**Planning Proposal – 47-51 Riley Street,
Woolloomooloo (as amended following public
exhibition)**

Planning Proposal: 47 – 51 Riley Street, Woolloomooloo

Figure 19 15. Proposed maximum building envelope as amended following public exhibition – 3D view from the north east

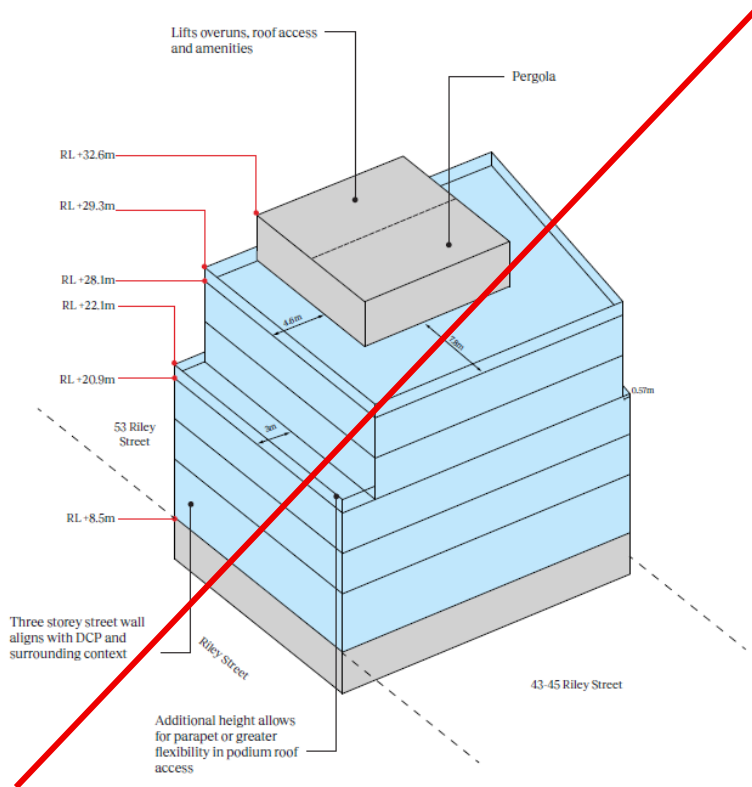
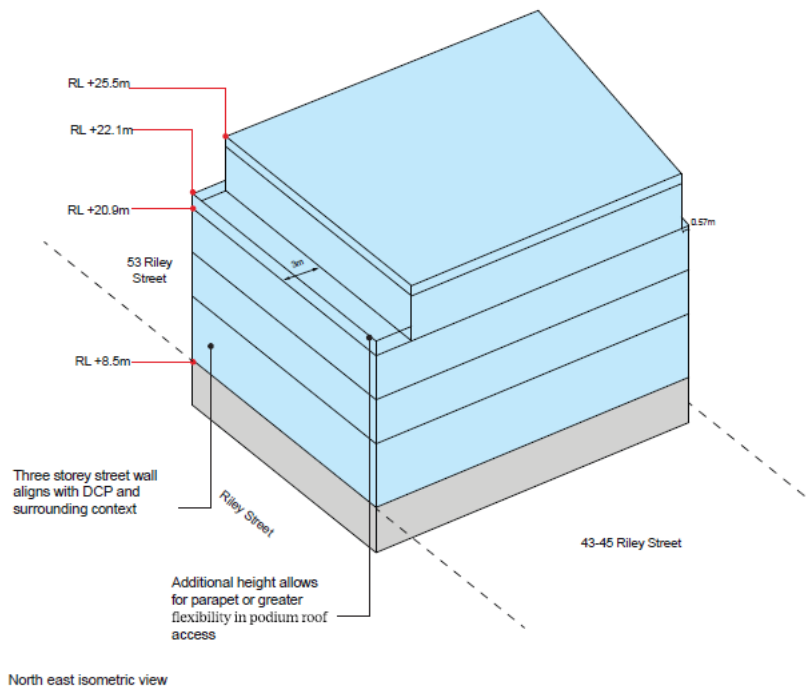
Following the detailed assessment of the planning proposal including site specific merits, post-exhibition changes are recommended to reduce the overall height, bulk and scale of the building envelope and reduce impacts on neighbouring residential properties. The indicative design drawings can no longer be relied upon as a depiction of a potential future development on the site.

The proposed height of ~~25 metres~~ **RL 25.5m** is considered reasonable in the context of the site's surrounds. ~~The recommended height reduction from the exhibited planning proposal will result in a better relationship with neighbouring buildings within the street block.~~ The height is compatible with the diversity of building heights in the vicinity, including low and mid-rise buildings in the immediate street block and the high rise developments to the east, west and south of the site.

The planning proposal will insert a site-specific building height control in Sydney LEP 2012, which will be available to support the commercial redevelopment of the site. The increase in the maximum building height from 12 metres to ~~25 metres~~ **RL 25.5m** would facilitate the increase in FSR. Site-specific DCP controls will establish a maximum building envelope, demonstrating the maximum permitted height, along with maximum street wall heights and setbacks.

Figure 23 19. Existing and proposed shadow impacts on residential façade of 60-70 William Street to the south (exhibited planning proposal)

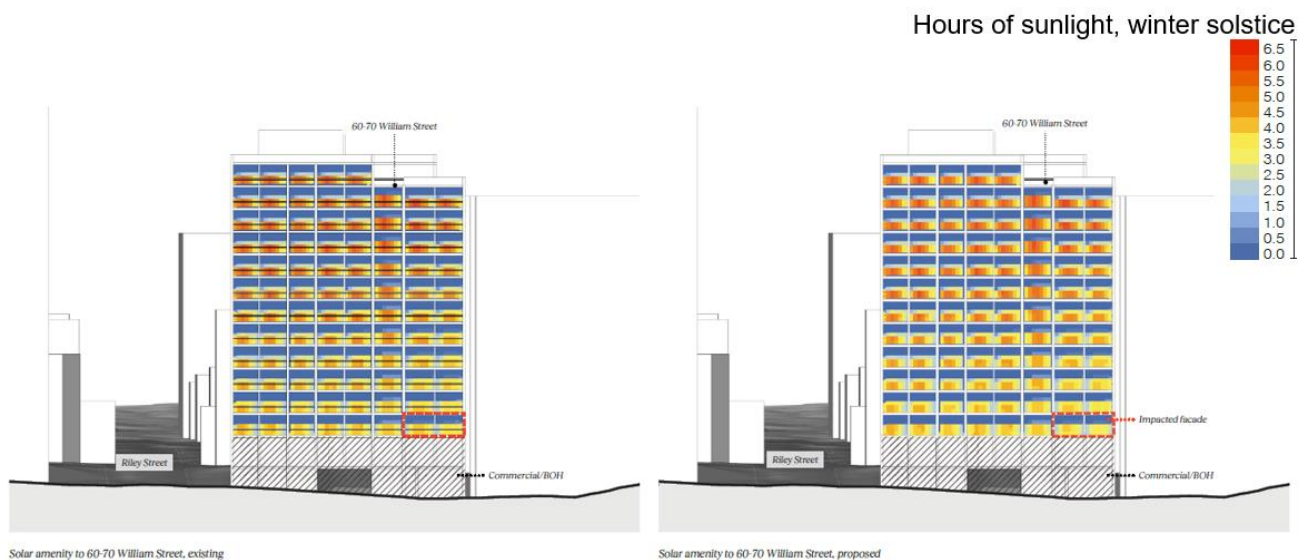
The proponent ~~has~~ prepared shadow diagrams for the exhibited planning proposal to show the potential overshadowing impact of the development on nearby properties, the results of which can be found in the Urban Design Report at Attachment A4 of this planning proposal.

The building at 60-70 William Street which is a mixed use development with residential apartments located to the south of the site, required further investigation. Façade testing of the northern elevation of this building showed that only 0.5% of the residential façade would experience additional overshadowing impacts, but that all apartments would continue to achieve ~~two~~ 2 hours of solar access in mid-winter. Figure 23 shows the existing and proposed solar impacts of the development on the residential façade of 60-70 William Street.

The recommended post-exhibition changes to the planning proposal to reduce the maximum building height and FSR will also have the effect of reducing the shadowing impacts of the building envelope.

Figure 25 23. Ground floor plan of indicative design showing retail use and commercial lobby fronting Riley Street

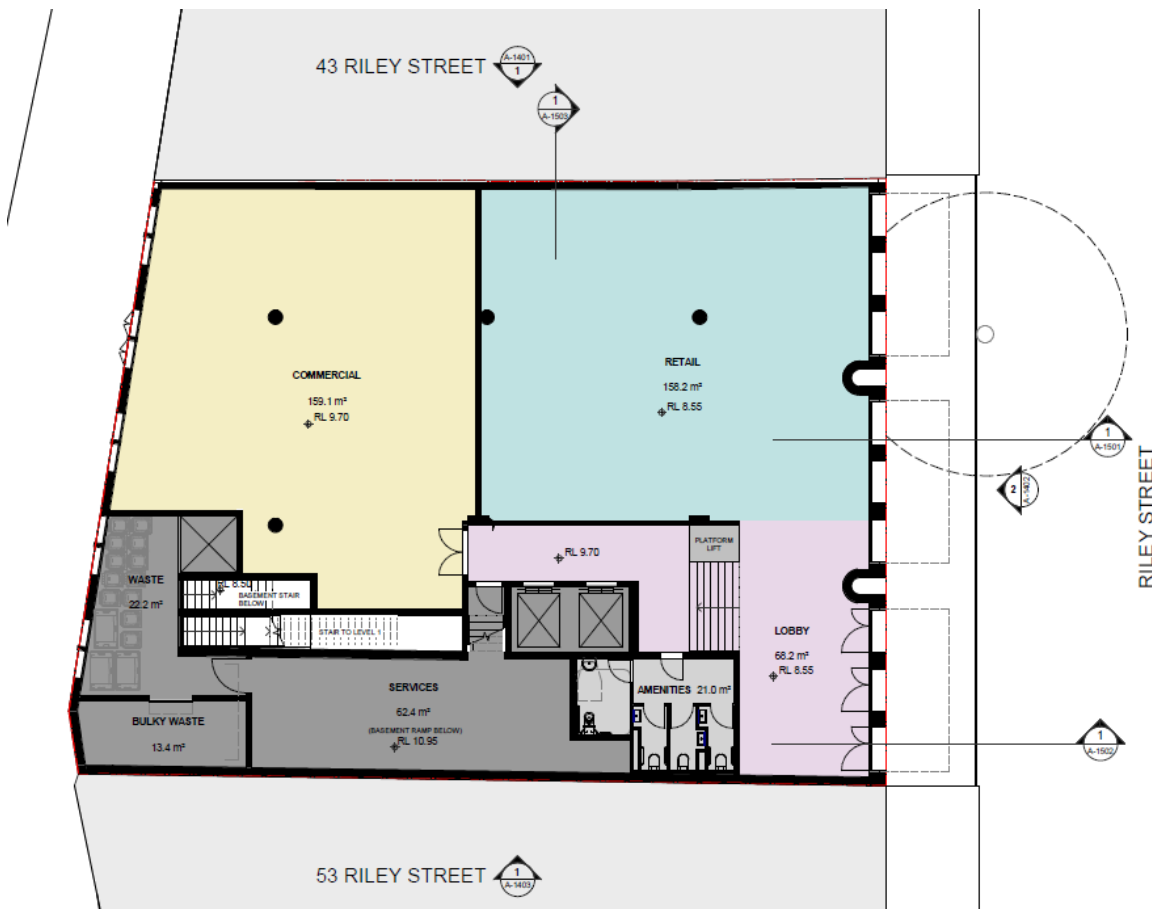
The planning proposal includes retail floor space at ground floor level fronting Riley Street, to contribute to the activation of the street front. The indicative reference scheme submitted as part of the planning proposal documentation shows a lobby for the building's commercial suites being accessed from the Riley Street frontage of the building. See Figure 25 23.

The City advised the proponent that the proposed floor levels for the retail and front lobby ~~are~~ in the indicative design were too low at RL 8.5m, and below the 10% Annual Exceedence Probability (AEP) for a flood event of RL8.85m and the 1% AEP for a flood event of 8.9m. The key concern at planning proposal stage was that addressing this may affect floor levels and therefore the overall height of the building envelope.

The proponent responded to this concern by raising the floor levels of the retail and front lobby area by 50mm, to a height of RL8.55m. The applicant advised that any future modification to lobby/retail levels would have no impact on the overall building height.

Following this amendment, the City's stormwater engineer has advised that the planning proposal is acceptable, but detailed Flood Impact and Risk Assessment (FIRA) and Flood Emergency Response Plan (FERP) reports are to be submitted in relation to future development applications relating to this site.

Figure 26 24. Indicative design of basement carpark

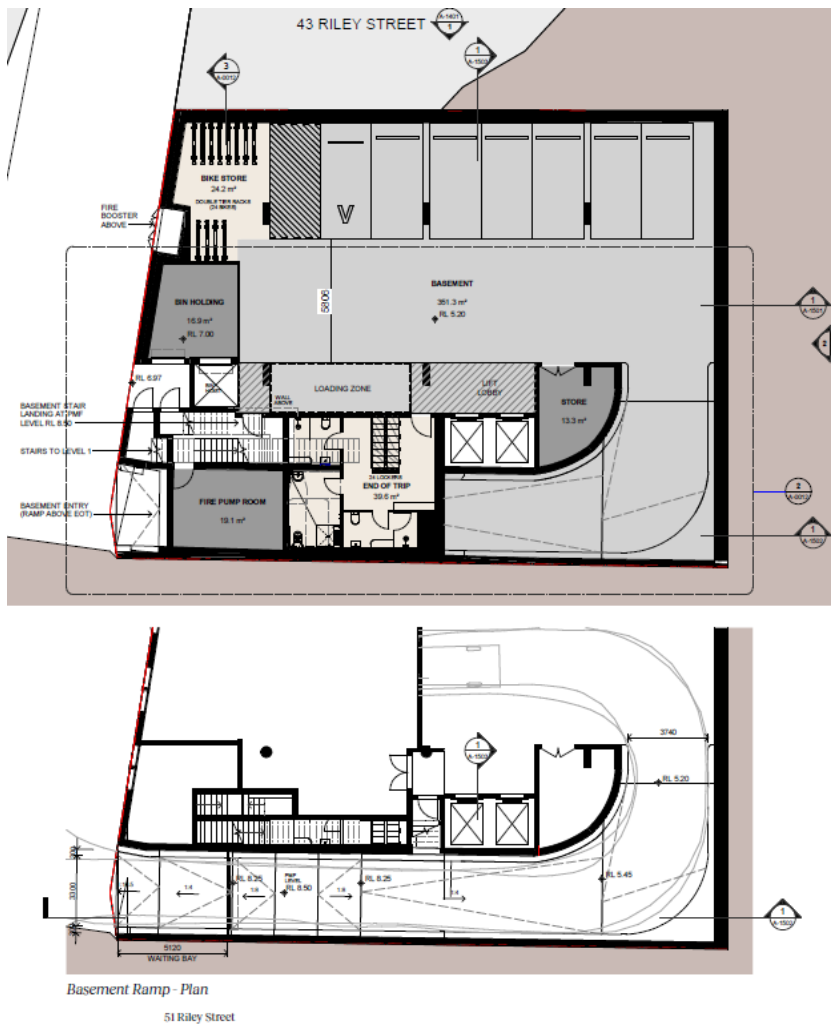
The indicative design submitted with the planning proposal proposes a basement carpark accessed from Busby Lane, but with the vehicular access point on the southern side of the Busby Lane frontage (rather than on the northern side as it is for the existing development on the site). The indicative design depicts a basement level accessed via a ramp with seven parking spaces (inclusive of one visitor space), a loading zone, a bike store for 24 bikes, end of journey facilities, a bin holding area and a fire pump room. See Figure 26 24.

With regard to vehicular entry and exit from the site, it appears that B99 vehicles appear not to be able to achieve clear entry and exit swept paths. Swept paths within the basement itself will also need to demonstrate how vehicles get into and out of the loading bay.

More detailed assessments will be needed as part of any future development application for the site, to ensure orderly waste servicing as well as safe vehicular movement into and out of the site and around the basement.
